F/CMVSS Noncompliance Recall

18159 Fuel Leak During F/CMVSS Testing

Reference Number: N182159480

Release Date: August 2018
Revision: 03

5118291

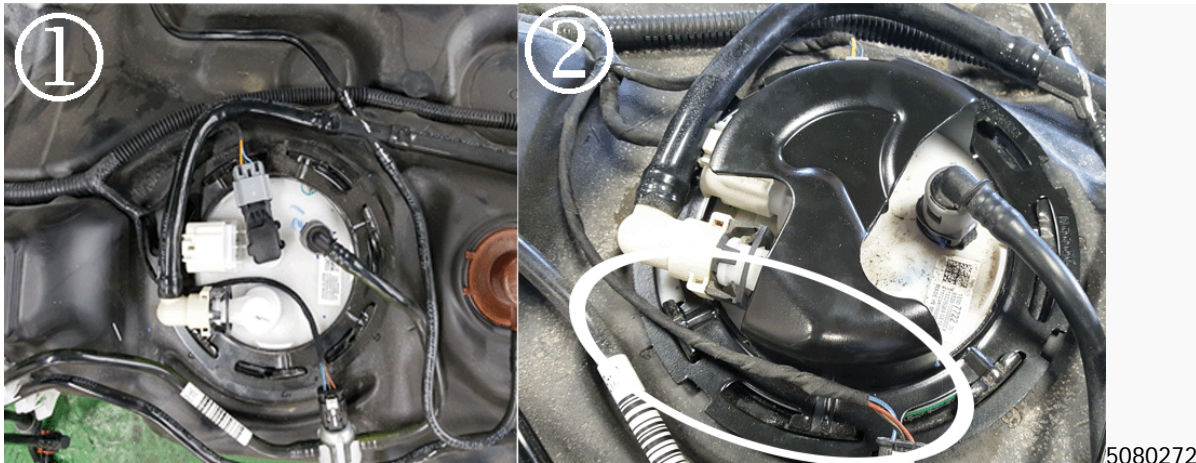
- Inspect the fuel tank label (facing the rear of the vehicle) and verify the julian date of production.
 - (1) Must be 18 or higher
 - (2) Must be 124 or higher
 - For (3), see below:
 - If (2) is 125 or higher, (3) may be any number.
 - If (2) is 124, (3) must be higher than 1072.

- If the Julian date meets these criteria, no further action is required. If the Julian date does NOT meet **any** of these criteria, proceed to step 4.
